PLANNING COMMITTEE

26 JANUARY 2023

Item 3: Public Questions (Bow Farm)

“10 questions for the Gloucestershire Planning Department and the Planning Committee regarding the sand and gravel extraction at Bow Farm under the Planning Application number 19/0081/TWMAJM.

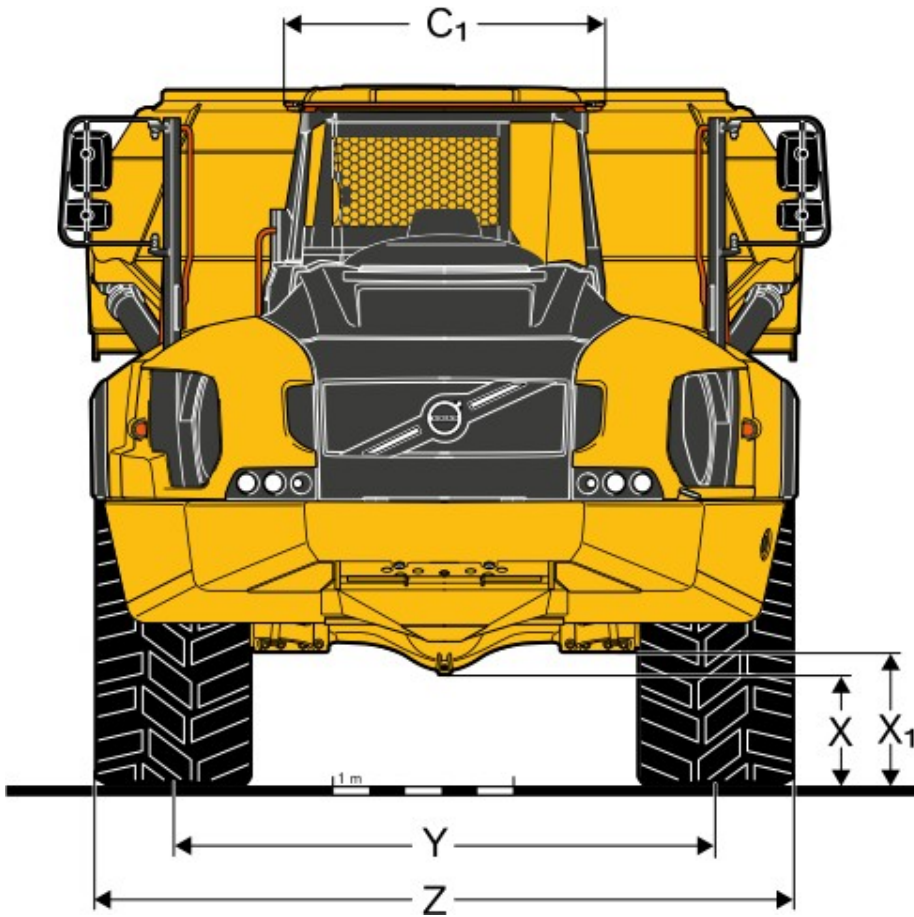
The rider shown below is 0.7m below the causeway used by the trucks - see below. Everything is as far as possible to scale.

The vehicle above is a typical large dumper truck used in a sand and gravel quarry. Because there are no details presented by the planners or the quarry applicant we have taken what would be required if the applicant's 50 dumper truck movements per day are correct. The vehicle is typically 3.8m high. Now we suspect the applicant has reduced the number of truck movements per day 'in error' and the reality is that there will be over 200 not 50. However the height of a typical truck for the reduced capacity would not be reduced that much - these are modular type vehicles, so it might be 3.4m not 3.8m high. Again in the absence of any meaningful information from the applicant or the planners we think the haul route will be raised some 0.6/0.7m above the level of the bridgeway as the area floods to a depth of at least 0.5m on a regular basis - it is on a flood plain. The horse and rider are scaled to approximately a 16 hands animal. You can see the problem. Note that the spacing between the truck and the rider is typical of what will occur on the bridgeway with a 1.6m post and rail fence - not shown. The vehicle shown does not have a flashing beacon light on the roof but most vehicles in use will have this feature.

Officer response (11): There would be no land raising to facilitate the proposed haul route.
